**UNITED STATES DEPARTMENT OF COMMERCE  
Patent and Trademark Office**

09/768,885 01/23/01 MORELAND

# Office Action Summary

The following title is suggested: "Electrically Heated Aircraft Deicer Panel With Stitched Heater Strand."

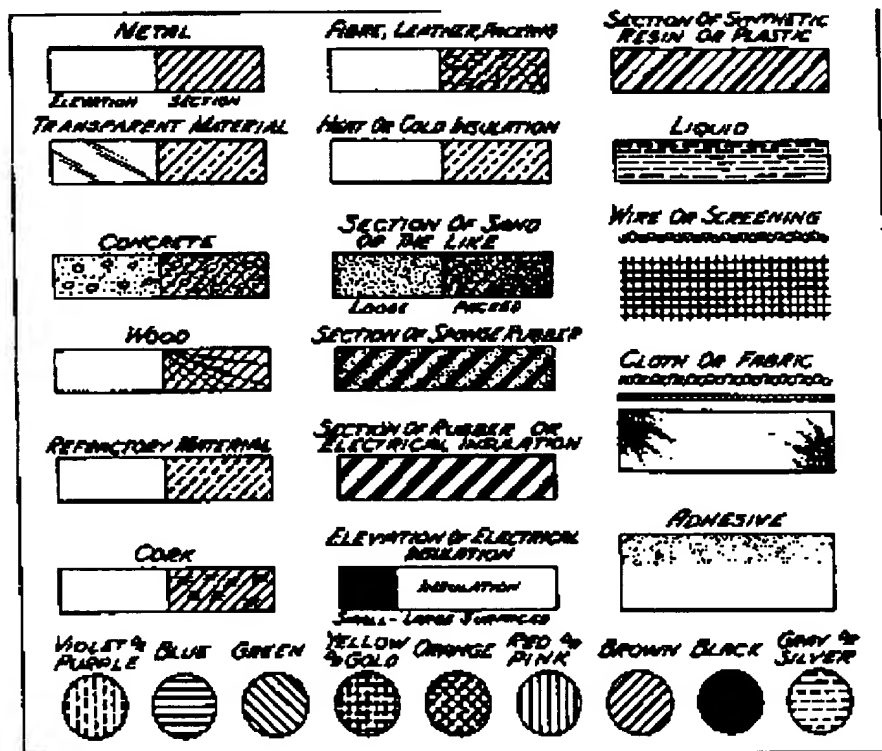
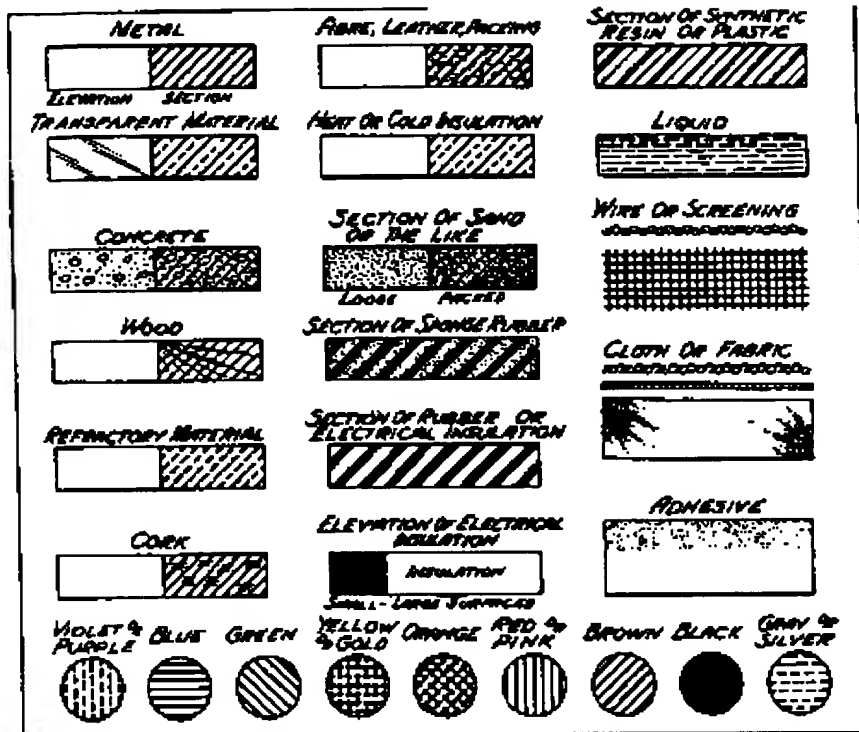
The drawings are objected to because of the following informalities:

An **additional cross sectional figure** is needed showing each layer of the finished deicer with proper cross sectional hatching for clarity. Proper cross-sectional hatching is required to properly denote appropriate materials in accordance with MPEP 608.02 (see the drawing below for proper hatching examples).

The response to this action must include a separate letter addressed to the examiner and contain: (1) sketches showing *in red* the drawing changes required above and (2) a request that the examiner approve the changes as shown on the sketches.
